Additions and Renovations
Platt Technical High School
Milford, CT

ADDENDUM NO. 3

August 2, 2019

scale
As Indicated

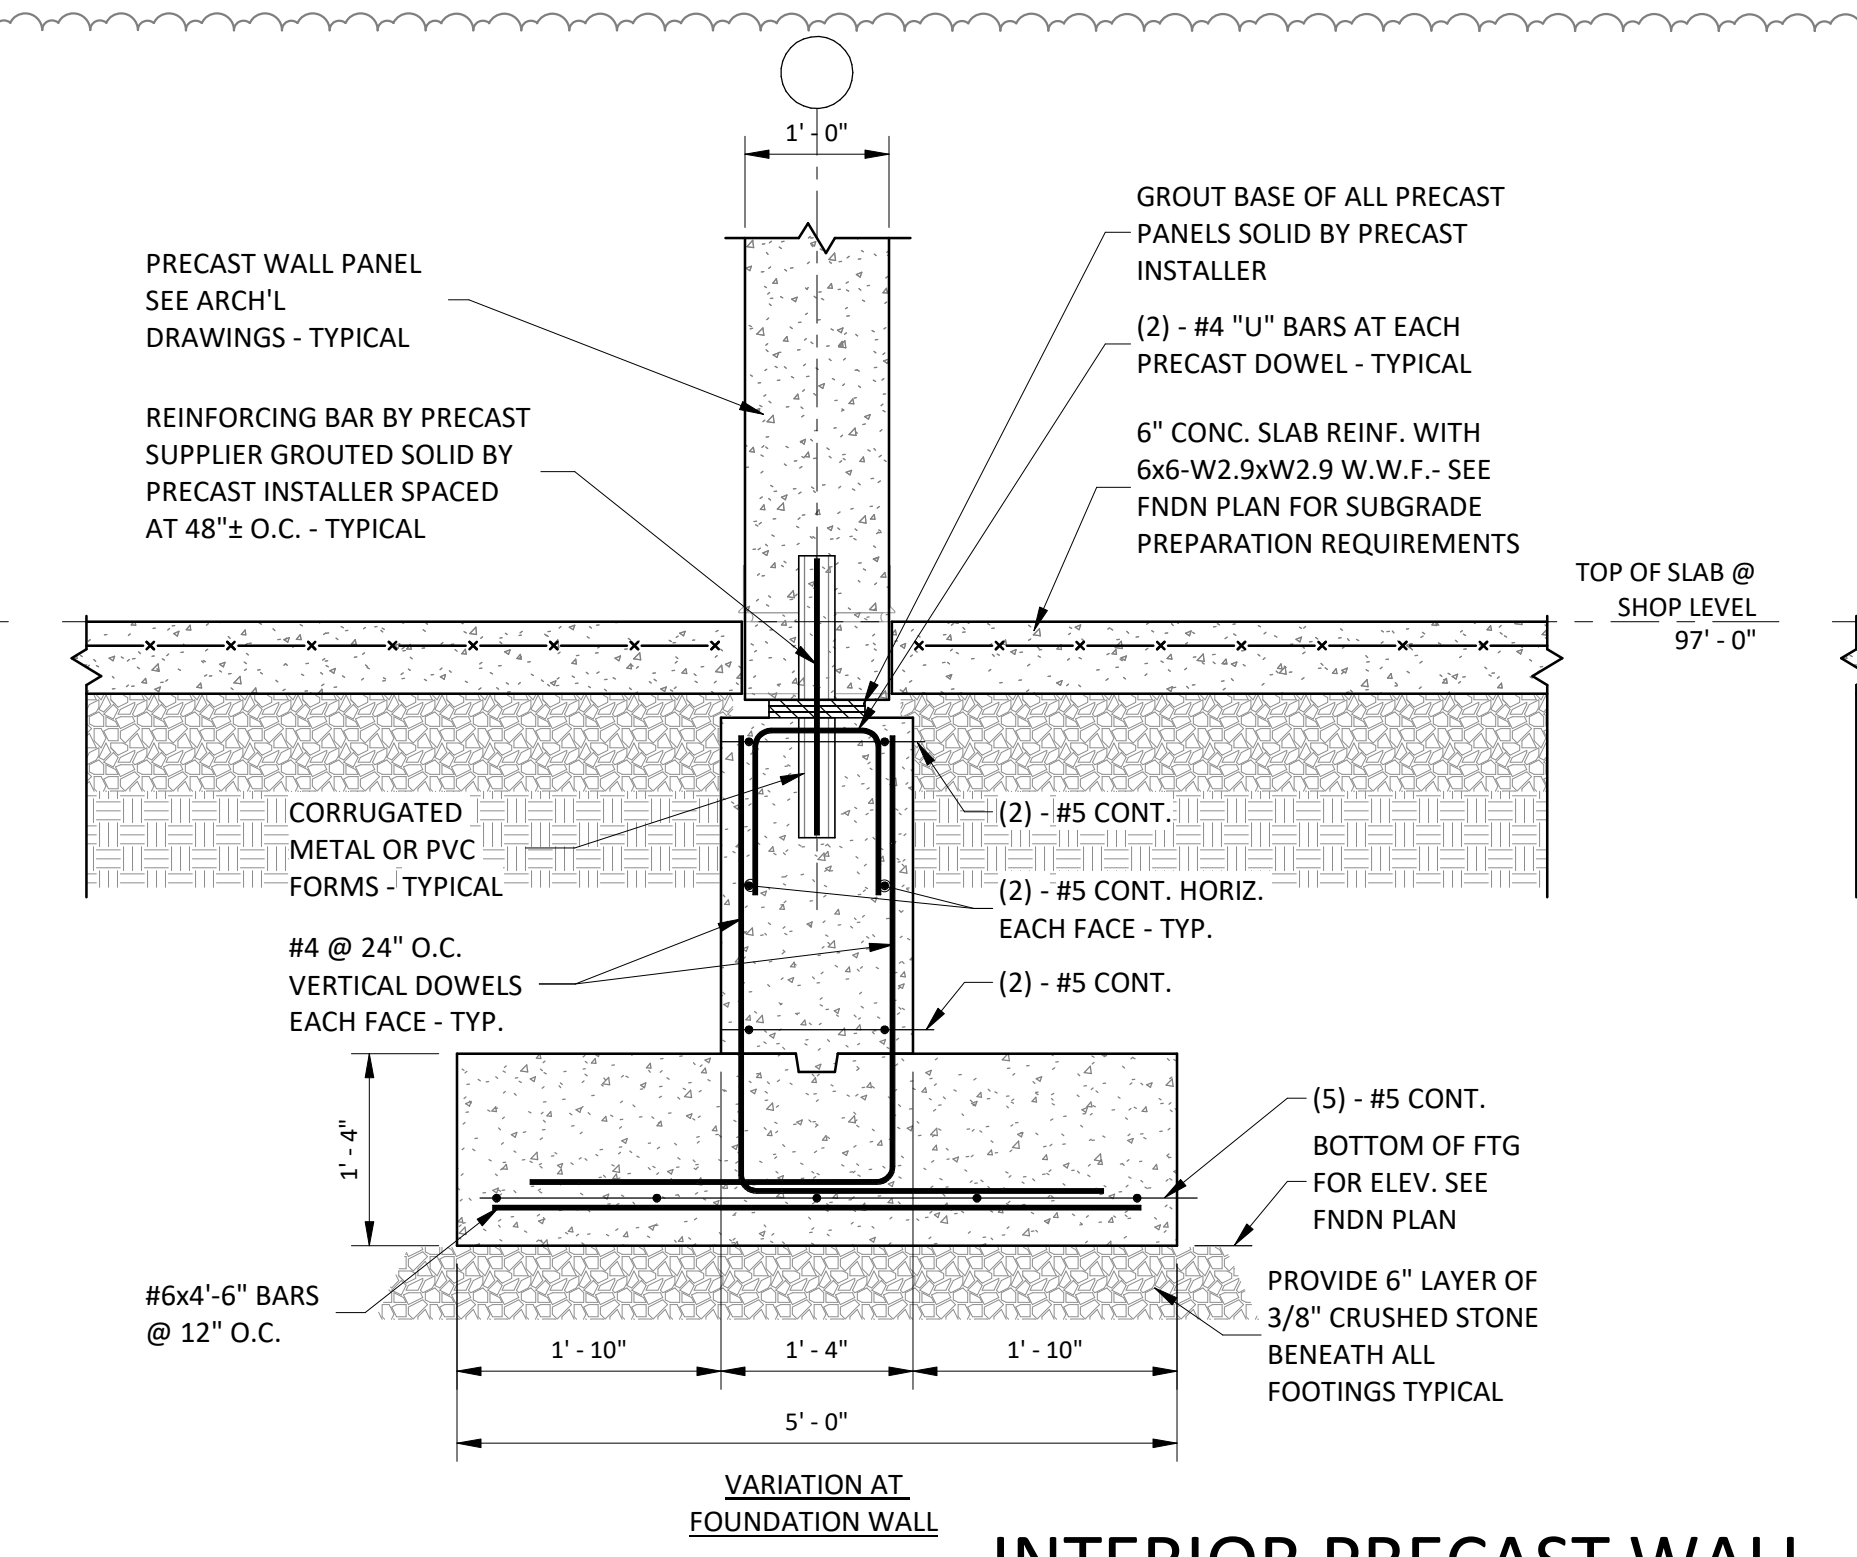
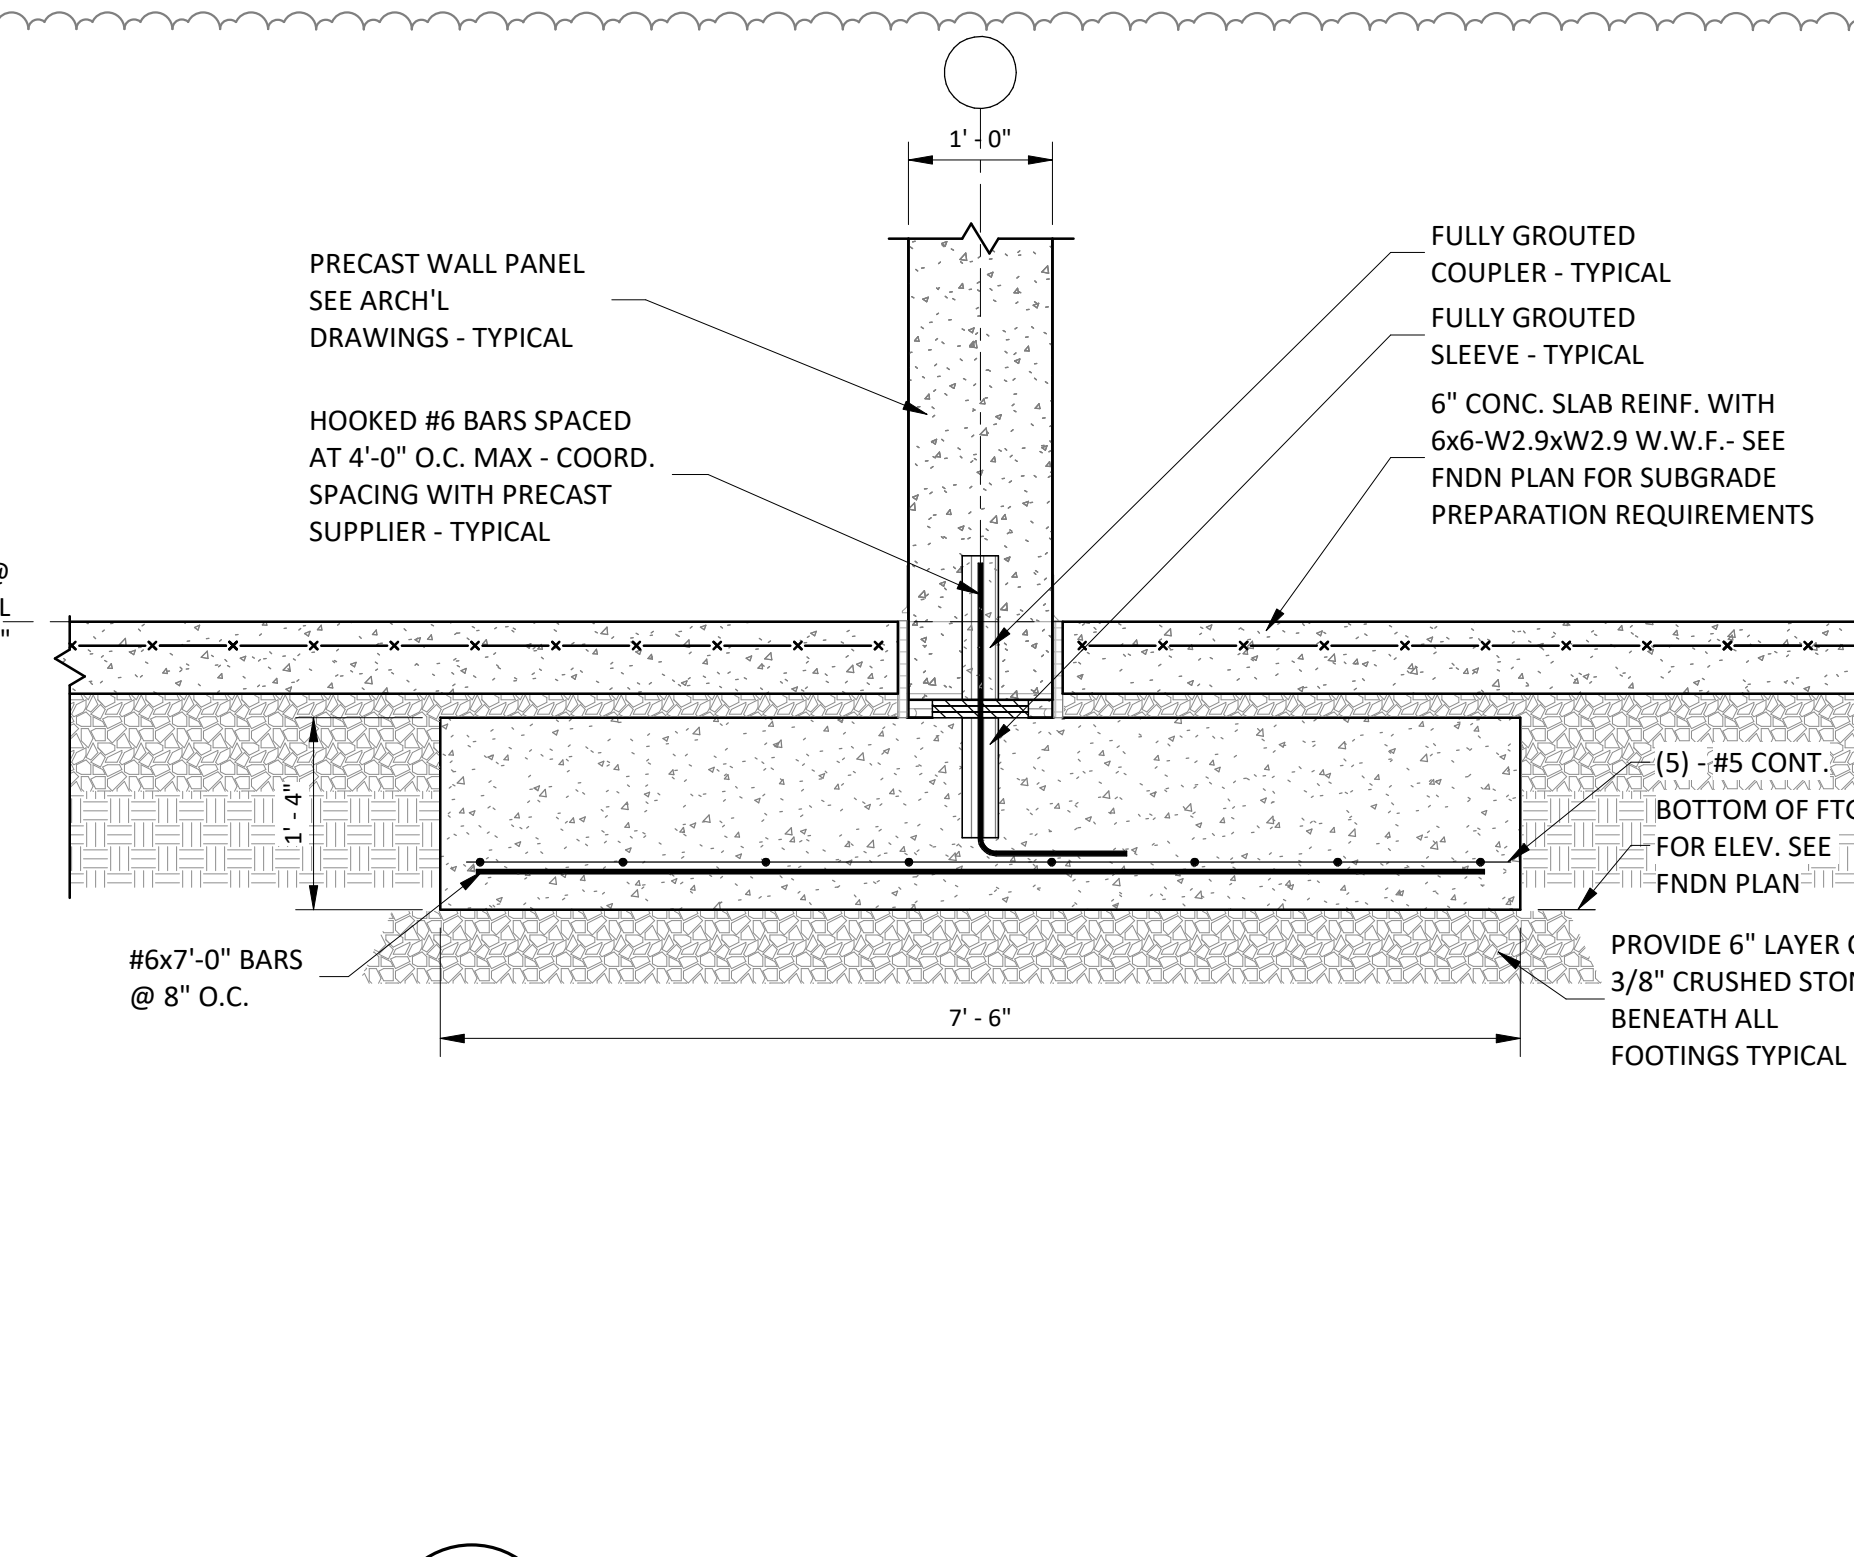
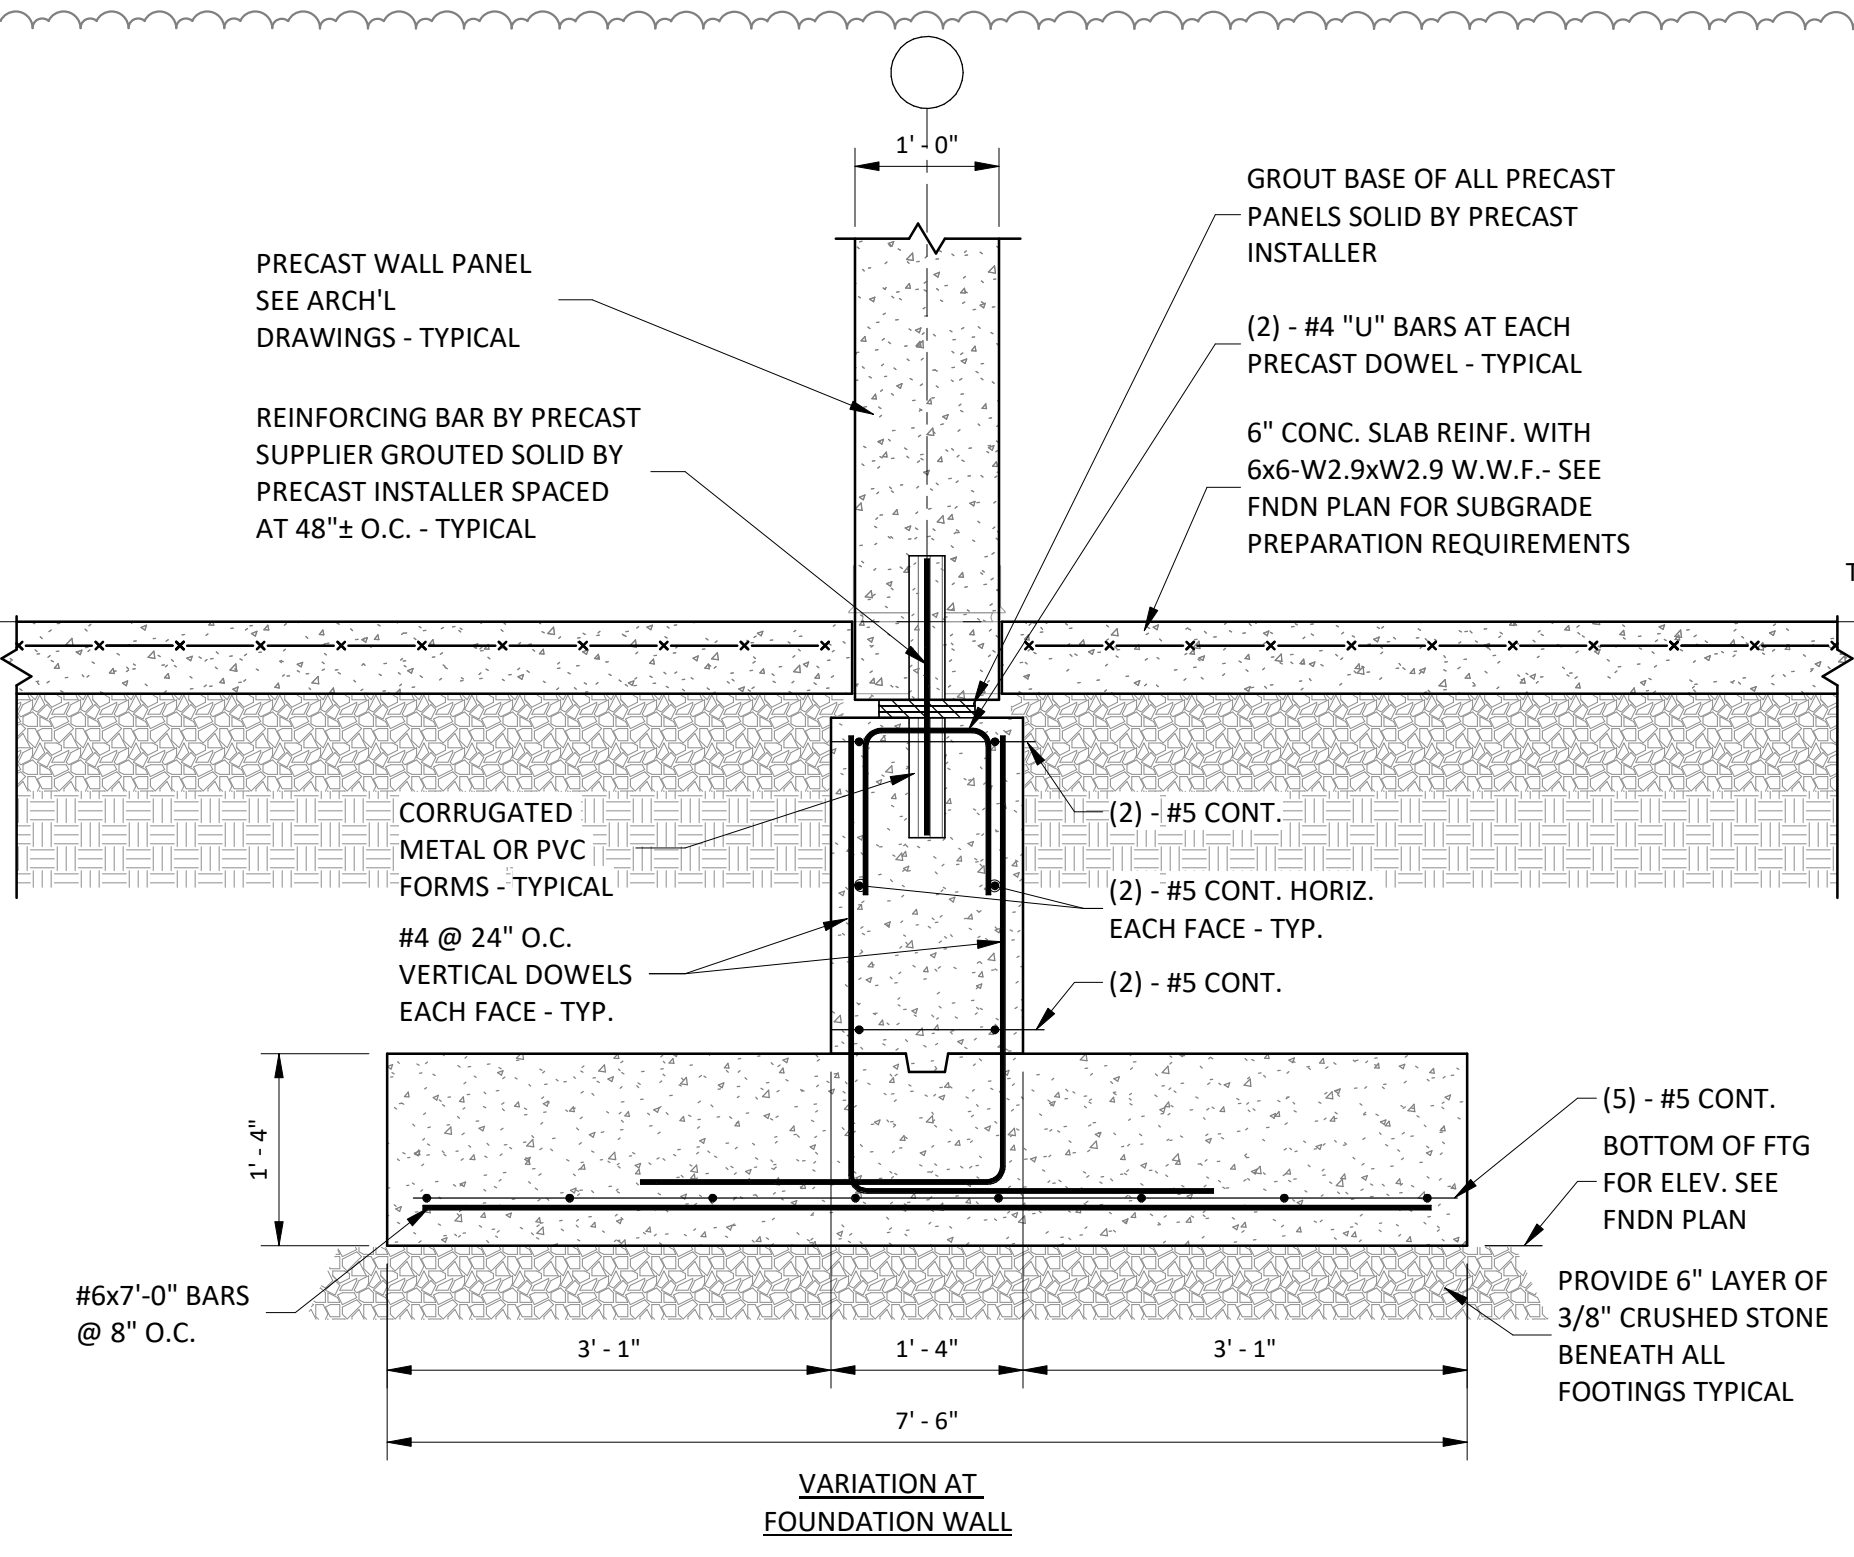
- ADD 3-076 DRAWING S2-4-1 – PRECAST BEAM & TEE SCHEDULE**
Revise Pre-cast Beam Schedule per Sketch RS3-005.
- ADD 3-077 DRAWING S3-2-2 – FOUNDATION PLAN DETAILS**
Added sections F1, F2, F3 for clarification per Revision RS3-2.

- ADD 3-078 DRAWING S3-2-2 – FOUNDATION PLAN DETAILS**
Added plan detail P3 per Revision RS3-001.
